BROWNS FERRY NUCLEAR PLANT, UNIT 1

AMENDMENT TO FACILITY OPERATING LICENSE

Amendment No. 190
License No. DPR-33

ATTACHMENT TO LICENSE AMENDMENT NO. 190

Figure 3.6-1
(BFN Unit 1)

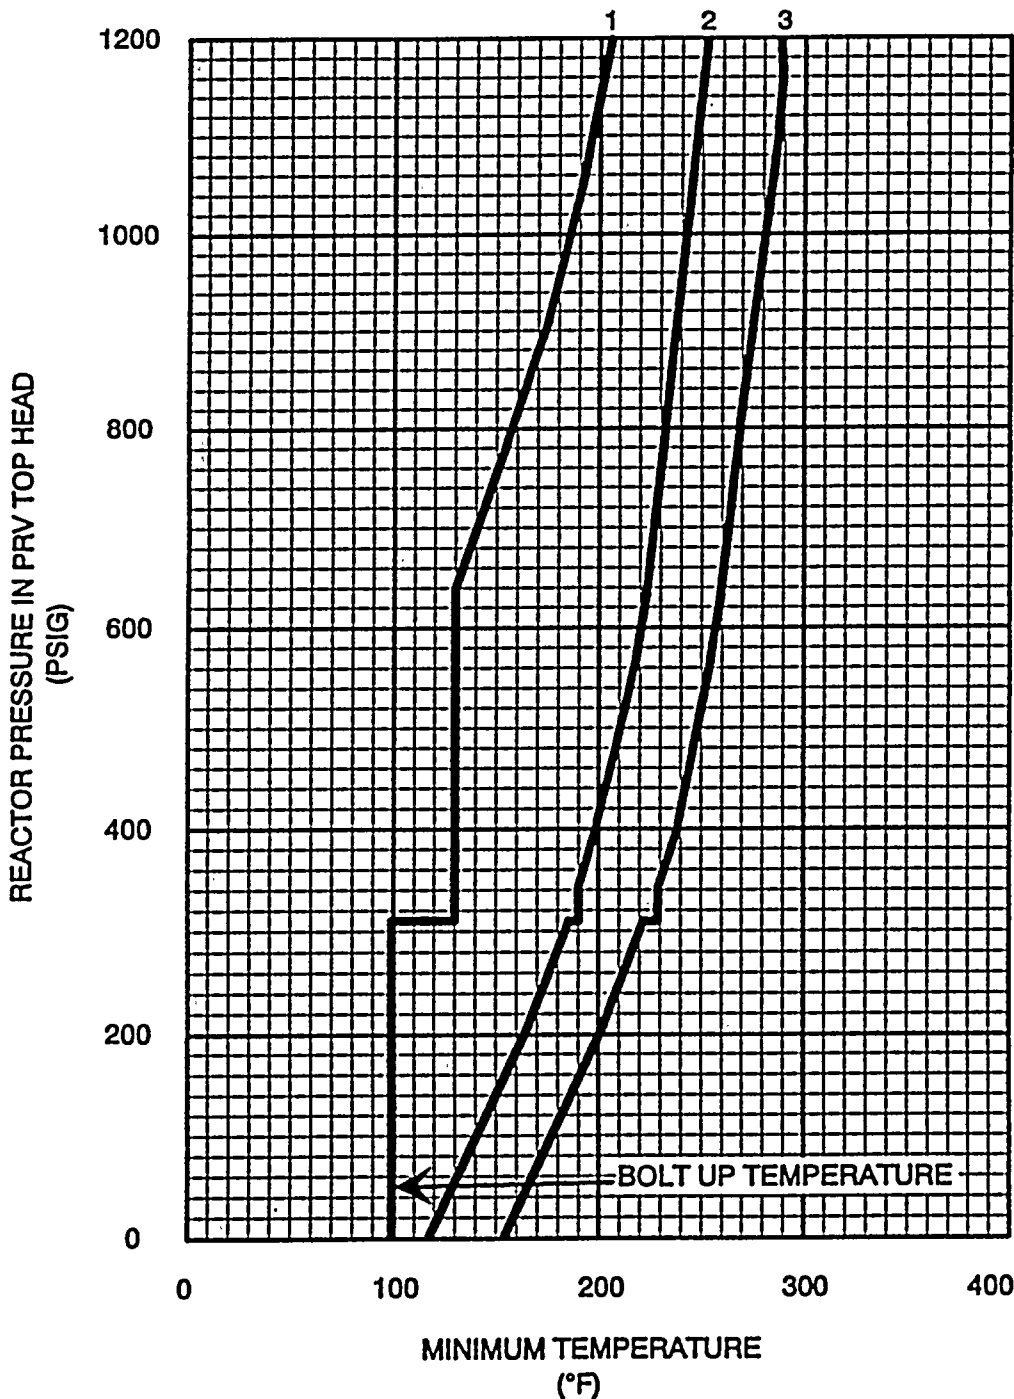
4. The beltline region of reactor vessel temperatures during inservice hydrostatic or leak testing shall be at or above the temperatures shown on curve #1 of Figure 3.6-1. The applicability of this curve to these tests is extended to nonnuclear heatup and ambient loss cooldown associated with these tests only if the heatup and cooldown rates do not exceed 15°F per hour.

Curve No. 1
Minimum temperature for pressure tests such as required by Section XI. Minimum temperature of 195 °F is required for test pressure of 1,100 psig.

Curve No. 2
Minimum temperature for mechanical heatup or cooldown following nuclear shutdown.

Curve No. 3
Minimum temperature for core operation (criticality) includes additional margin required for 10CFR50, Appendix G, Par. IV.A.3 which became effective July 26, 1983.

Notes
These curves include sufficient margin to provide protection against feedwater nozzle degradation. The curves allow for shifts in RT_{NDT} of the Reactor vessel beltline materials, in accordance with Reg. Guide 1.99 Rev. 2, to compensate for radiation embrittlement for 12 EFPY.

Figure 3.6.-1
(BFN Units 2 and 3)

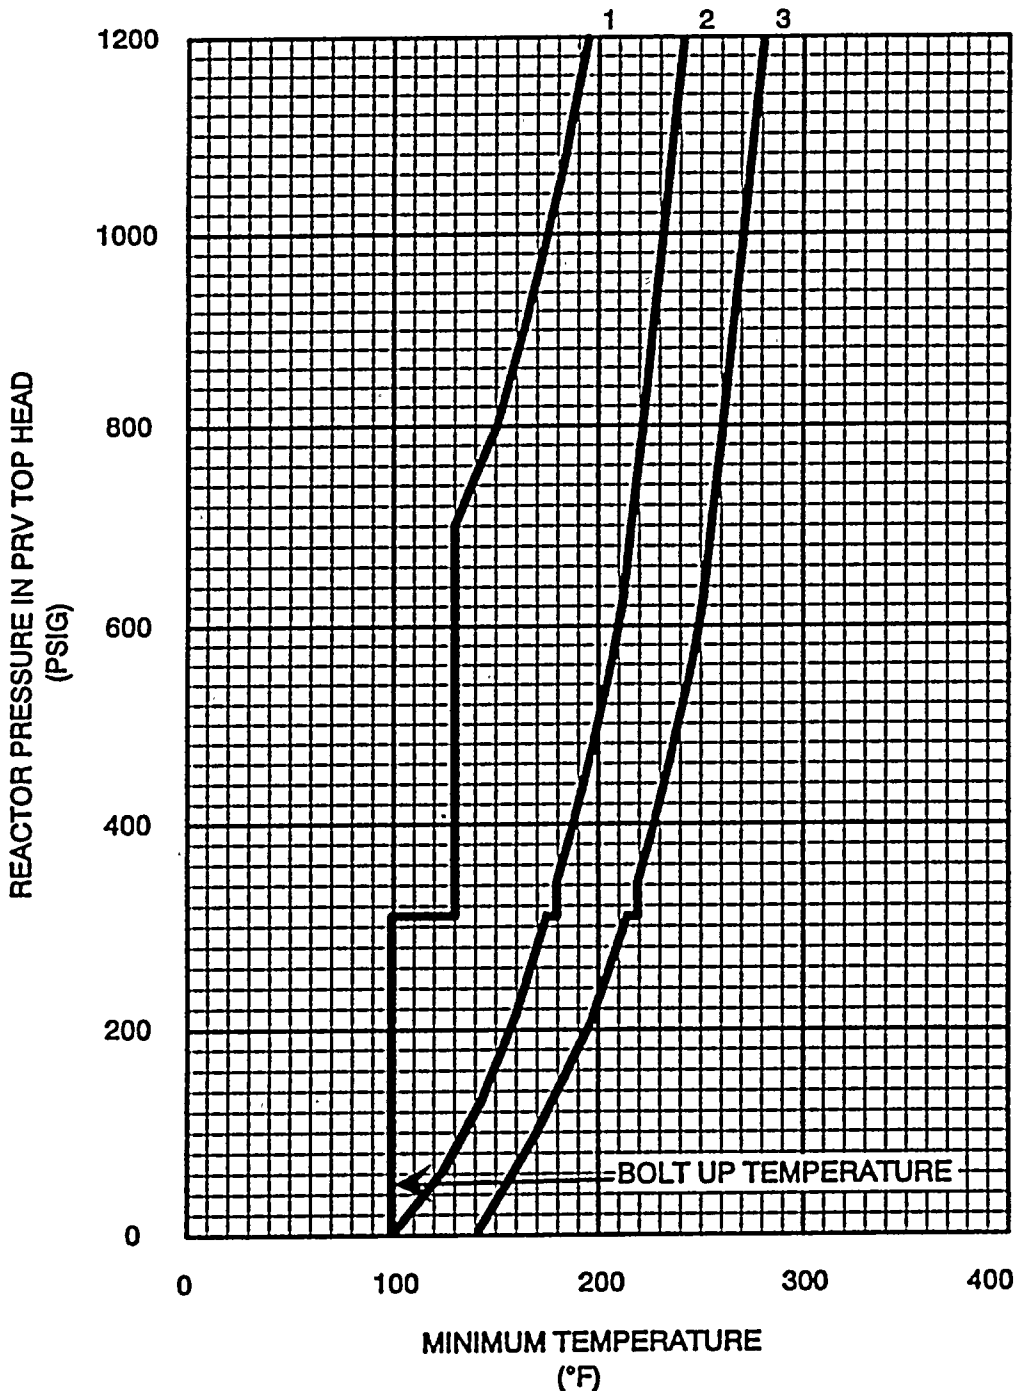
4. The beltline region of reactor vessel temperatures during inservice hydrostatic or leak testing shall be at or above the temperatures shown on curve #1 of Figure 3.6-1. The applicability of this curve to these tests is extended to nonnuclear heatup and ambient loss cooldown associated with these tests only if the heatup and cooldown rates do not exceed 15°F per hour.

Curve No. 1
Minimum temperature for pressure tests such as required by Section XI. Minimum temperature of 185 °F is required for test pressure of 1,100 psig.

Curve No. 2
Minimum temperature for mechanical heatup or cooldown following nuclear shutdown.

Curve No. 3
Minimum temperature for core operation (criticality) includes additional margin required for 10CFR50, Appendix G, Par. IV.A.3 which became effective July 26, 1983.

Notes
These curves include sufficient margin to provide protection against feedwater nozzle degradation. The curves allow for shifts in RT_{NDT} of the Reactor vessel beltline materials, in accordance with Reg. Guide 1.99 Rev. 2, to compensate for radiation embrittlement for 12 EFPY.

Figure 3.6.-1
(BFN Units 2 and 3)

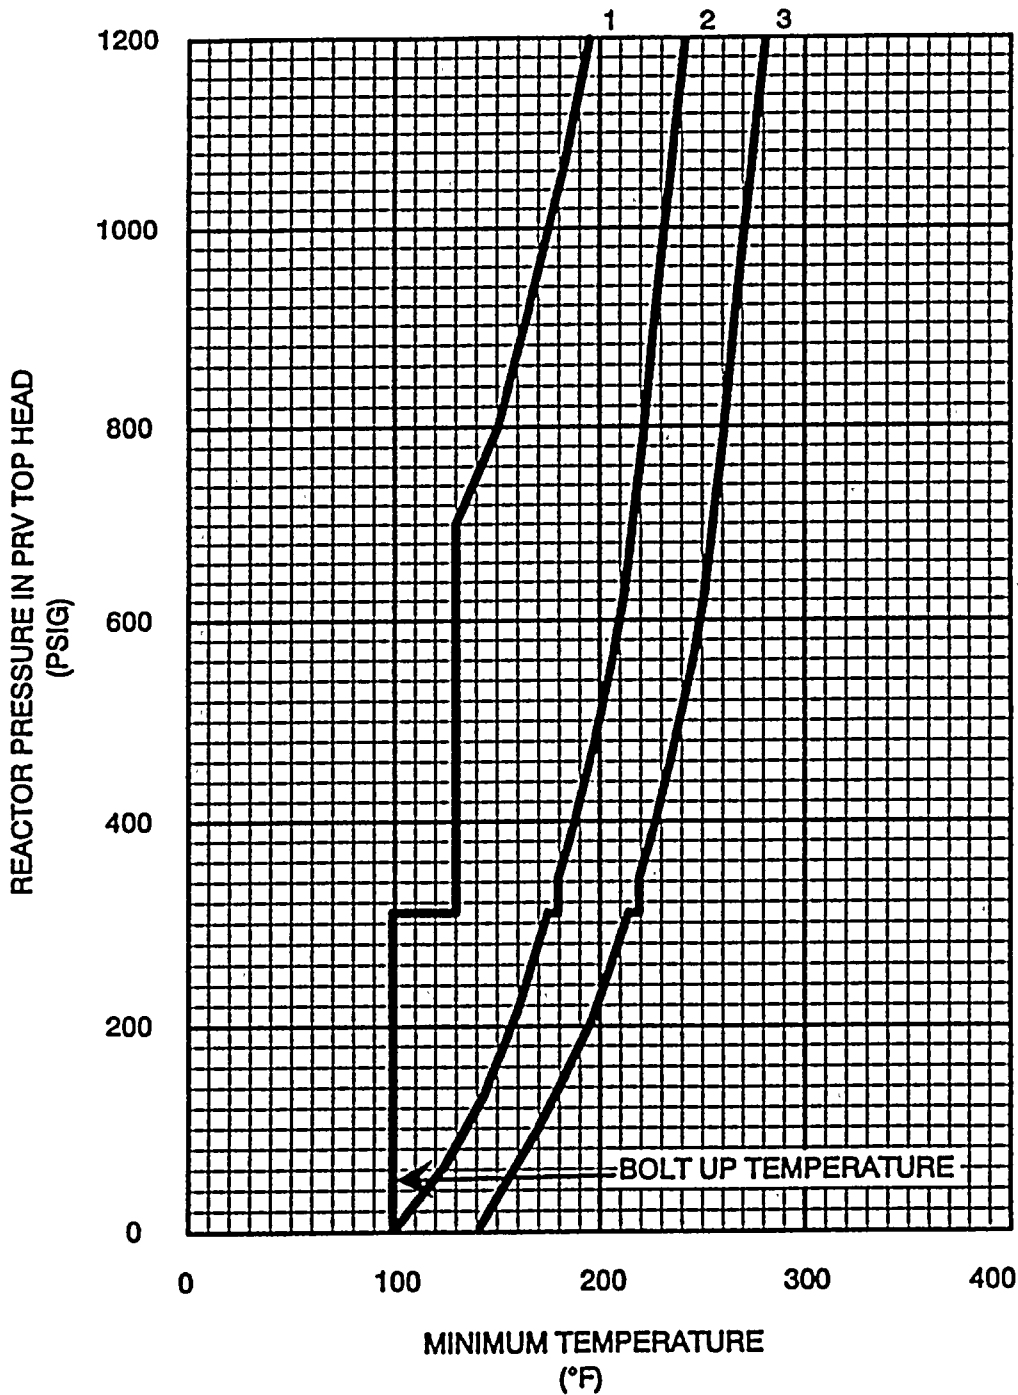
4. The beltline region of reactor vessel temperatures during inservice hydrostatic or leak testing shall be at or above the temperatures shown on curve #1 of Figure 3.6-1. The applicability of this curve to these tests is extended to nonnuclear heatup and ambient loss cooldown associated with these tests only if the heatup and cooldown rates do not exceed 15°F per hour.

Curve No. 1
Minimum temperature for pressure tests such as required by Section XI. Minimum temperature of 185 °F is required for test pressure of 1,100 psig.

Curve No. 2
Minimum temperature for mechanical heatup or cooldown following nuclear shutdown.

Curve No. 3
Minimum temperature for core operation (criticality) includes additional margin required for 10CFR50, Appendix G, Par. IV.A.3 which became effective July 26, 1983.

Notes
These curves include sufficient margin to provide protection against feedwater nozzle degradation. The curves allow for shifts in RT_{NDT} of the Reactor vessel beltline materials, in accordance with Reg. Guide 1.99 Rev. 2, to compensate for radiation embrittlement for 12 EFY.
